Gatwick Airport Northern Runway Project

Second Notification of a Proposed Project Change

Application Document Ref: 10.27

Change 4: Provision of an on-airport Wastewater Treatment Works

Figure 1: Location of the on-airport WWTW facility

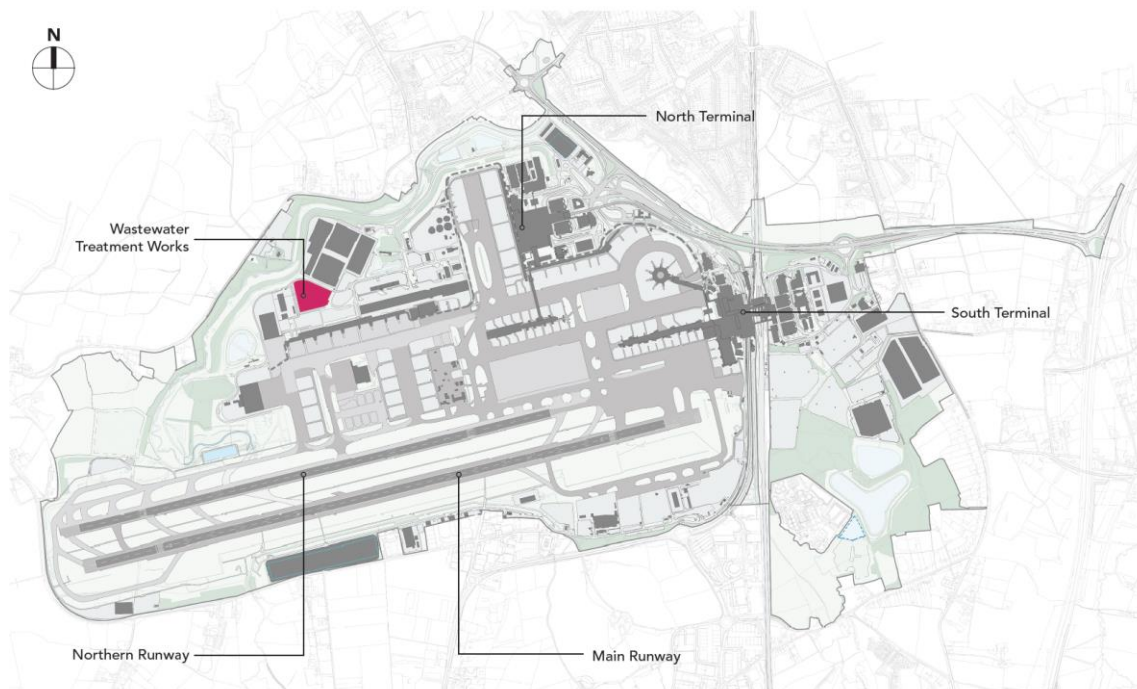
- 1.4.3 The location of the proposed on-airport WWTW is shown in pink in **Figure 1** below.

- 2.1.5 Project Change 4 comprises the:
- Provision of an on-airport Wastewater Treatment Works (WWTW) facility, located within existing Self-Park North car park shown on **ES Figure 4.2.1b** [[REP1-019](#)] and in **Figure 1** above.

Figure 2: Indicative Layout of the on-airport WWTW facility

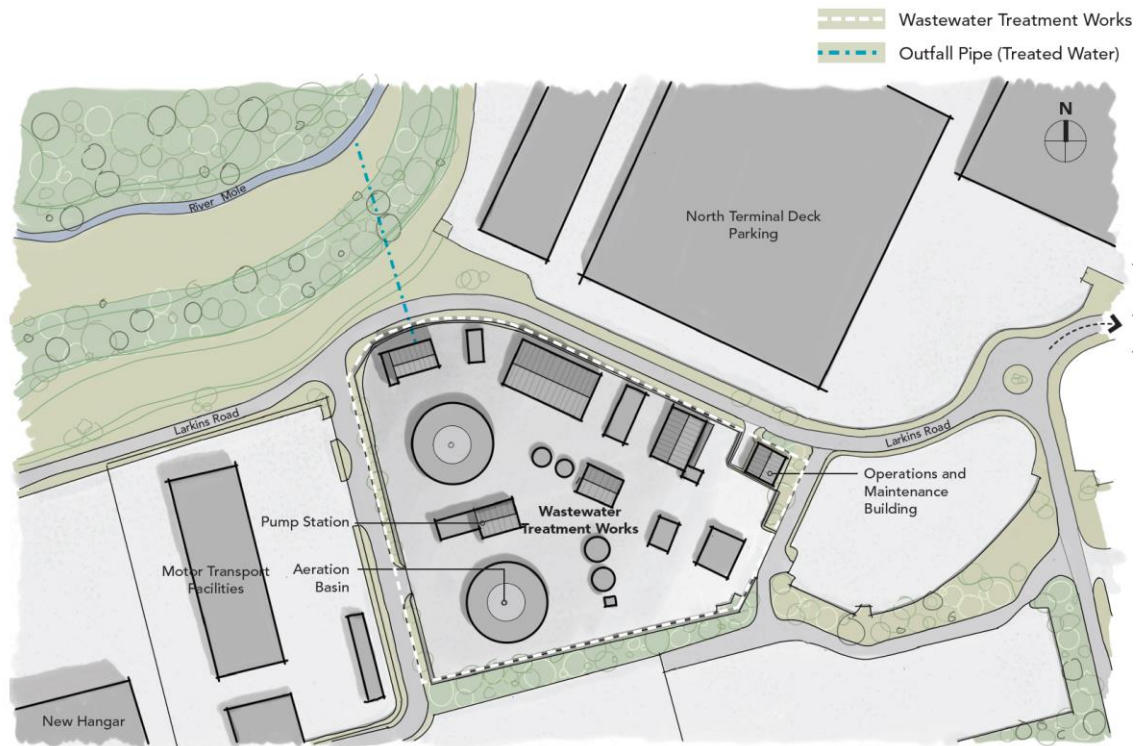
2.1.6 The on-airport WWTW facility would require a footprint of approximately 2.2 hectares. The facility would include the following physical elements, with the maximum height of the proposed structures being up to 9.4m above ground level and up to 2m below ground level:

- Headworks (the entry point for raw wastewater);
- Two circular primary clarifiers, each of approximately 12m in diameter;
- Two aeration basins, each with secondary clarifiers;
- Gravity thickeners;
- Biotower (odour control facility);
- Rotary drum thickeners, belt filter presses and tertiary disk filter facilities, each housed in a dedicated building;
- Blower building accommodating 4 blowers;
- Chemical storage building;
- Associated pipelines and pumping stations;
- Flocculation tank and a rapid mix tank;
- Sludge blend facility and sludge storage area;
- Operations and maintenance building (up to 2-storeys);
- Truck loading area; and
- Outfall from the facility to the River Mole, involving a concrete structure beside the River Mole.

2.1.7 The physical elements within the on-airport WWTW facility are shown on an indicative layout in **Figure 2** below.
